1140/1141_12 and 36 Volt Solenoid

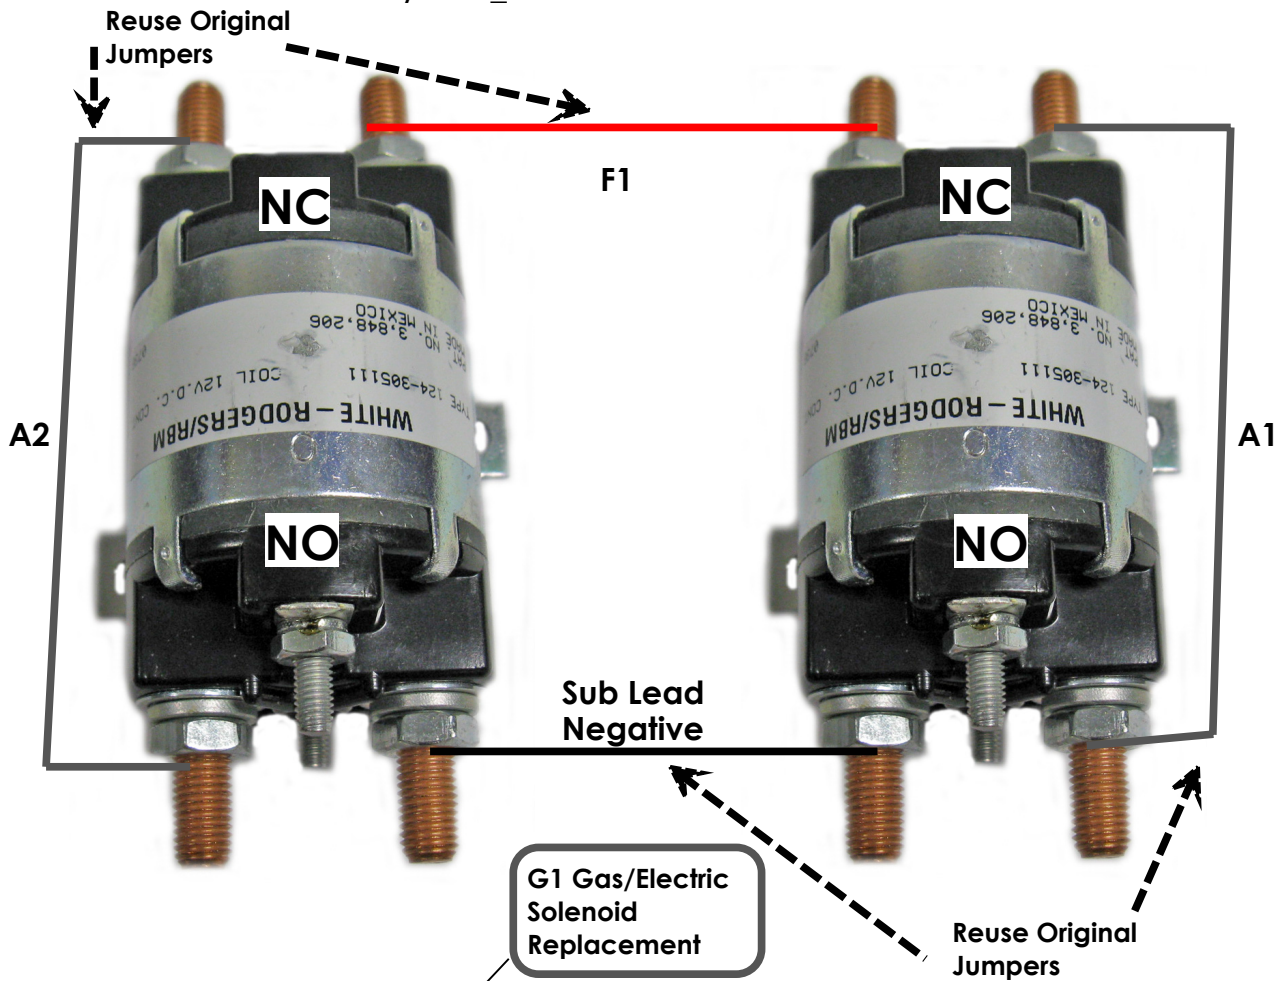
The O.E.M. solenoid contacts are opposite to the new replacement. The old style has normally open (NO) contacts on the two pole end. The four pole end is normally closed (NC). The replacement solenoid is NO on the four pole end and NC on the two pole end.

Electric Carts:
 A1 is F1 and A2 is F2. Battery positive connects to NO end and the resistor lead cable connects to the NC end. The battery charging lead wire connects to positive at NO.

Gas Cars:
 F1 cable connects to NC end of solenoid.
 Battery negative cable connects to NO end of solenoid with the Sub Lead wire.
